## Issue List

- 1 INCORRECT GRILLE - KITCHEN
- CONDENSER DRAIN IN THE WAY OF DOOR
- EF1 NO SPEED CONTROLLER
- INACCESSIBLE DAMPER

02-09-26 QT #0489 CASA GRANDE, AZ

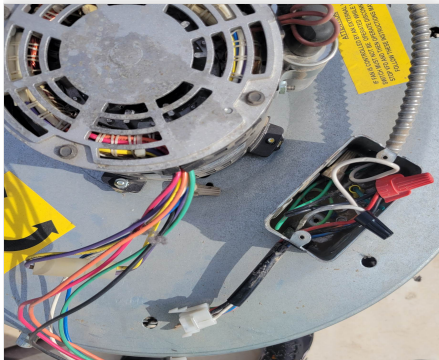
**Issue Name :** CONDENSER DRAIN IN THE WAY OF DOOR  
**Description :** The door to the mixed air compartment cannot be opened very far, due to the drain being in the way. The economizer control could barely be reached. Recommend adjusting drain to allow full access.  
**Created By :** National TAB                      **Assigned To :** National TAB - Dan Hertenstein  
**Status :** Open  
**Priority :** Low                                      **Asset Tag :** RT-3  
**Originated Date :** 02/13/2026 - Christine Weale - National TAB

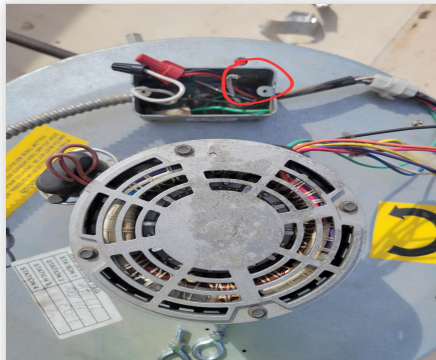
**Issue Name :** EF1 NO SPEED CONTROLLER  
**Description :** When I arrived, EF1 was improperly wired and not running, I fixed it, but it was running way too high so I disconnected the fan for safety. There should be a safety disconnect switch and a speed control. Fan speed may also be controlled via wiring. No disconnect switch, so power unplugged at the motor connector.  
**Created By :** National TAB      **Assigned To :** National TAB - Dan Hertenstein  
**Status :** Open  
**Priority :** Urgent      **Asset Tag :** EF1  
**Originated Date :** 02/13/2026 - Christine Weale - National TAB
